**PLANNED UNIT DEVELOPMENT  
& SUBDIVISION STAFF REPORT****March 1, 2018**

<b><u>DEVELOPMENT NAME</u></b>	The Shoppes at Rangeline Subdivision
<b><u>SUBDIVISION NAME</u></b>	The Shoppes at Rangeline Subdivision
<b><u>LOCATION</u></b>	4439 Rangeline Road Northwest corner of Rangeline Road and Halls Mill Road.
<b><u>CITY COUNCIL DISTRICT</u></b>	District 4
<b><u>AREA OF PROPERTY</u></b>	2 Lots / 2.0 ± acres
<b><u>CONTEMPLATED USE</u></b>	Planned Unit Development Approval to allow shared access and parking between multiple building sites, and to create two legal lots or record from one existing legal lot.
<b><u>TIME SCHEDULE FOR DEVELOPMENT</u></b>	None given.

# SITE PLAN

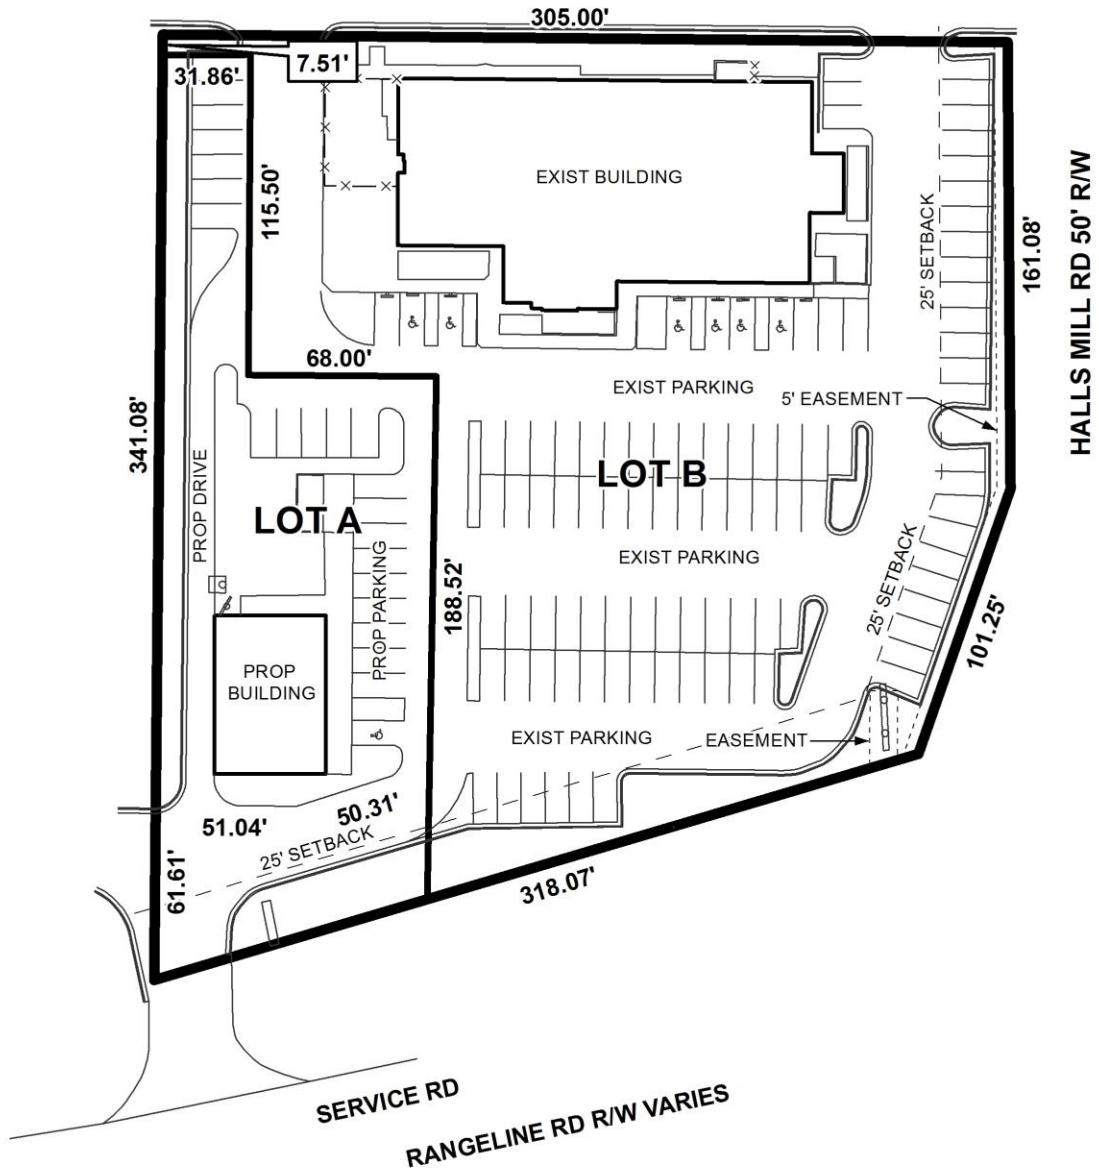
With regards to parking requirements, the retail/ office building and restaurant located on Lot B will require 45 parking spaces. Although the site plan does not depict the square footage of the outdoor dining area for the proposed restaurant on Lot A, staff was able to determine that an additional 380 square feet  $\pm$  of outside dining will be provided; thus requiring an estimated 24 parking spaces for drive-thru restaurant with outdoor dining area. Therefore a total of 89 parking spaces will be required for the site; the site plan depicts a total of 119 parking spaces. The site plan erroneously depicts the total parking spaces required as 66 parking spaces instead of the 89. The site plan should be revised to depict the total square footage of the outdoor seating space, and the above numbers listed for the parking requirements in the parking table on the site plan.

It should also be pointed noted that the parking spaces on Lot B closes to the building do not depict bumper stops on the last two parking spaces, thus encroachment into a pedestrian area may occur. The site plan should be revised to depict bumper stops on all the front parking spaces. It appears that curbing is provided on Lot A in front of the parking spaces adjacent to the drive-thru restaurant, however if curbing is not provided, the site plan should be revised to depict bumper stops in front of those parking spaces closest to the building as well.

With regards to tree and landscaping, the site plan does not actually depict the trees and landscaping on the site plan, but does provide a chart. As typically required by the Planning Commission for PUD's, the site will be required to provide frontage trees along the Rangeline Road Service Road and Halls Mill Road as well as parking trees for the new construction and compliant landscaping.

It should be noted that staff cannot determine if there is adequate space between the order menu board and the pick-up window on Lot A because the drive-thru window is not clearly identified. It does appear that sufficient room is providing for queuing spaces for the drive-thru, but without the location of the pick-up window being identified, staff cannot make a final determination. The site plan should be revised to depict the location of the pick-up window.

A sidewalk is not depicted on the site plan. The placement of a sidewalk along Halls Mill Road and the Rangeline Road Service Road or the submission of a sidewalk waiver will be required.

- 1) revision of the site plan depict the total square footage of the outdoor seating space, and correction of the numbers listed for the parking requirements in the parking table on the site plan;
- 2) revision of the site plan to depict bumper stops on the last two parking spaces on Lot B;
- 3) revision of the site plan to depict bumper stops along the parking spaces adjacent to the drive-thru restaurant on Lot A if curbing is not provided;
- 4) revision of the site plan to depict the order pick-up window on Lot A;
- 5) revision of the site plan to depict a sidewalk on the property, or the submission of a sidewalk waiver;
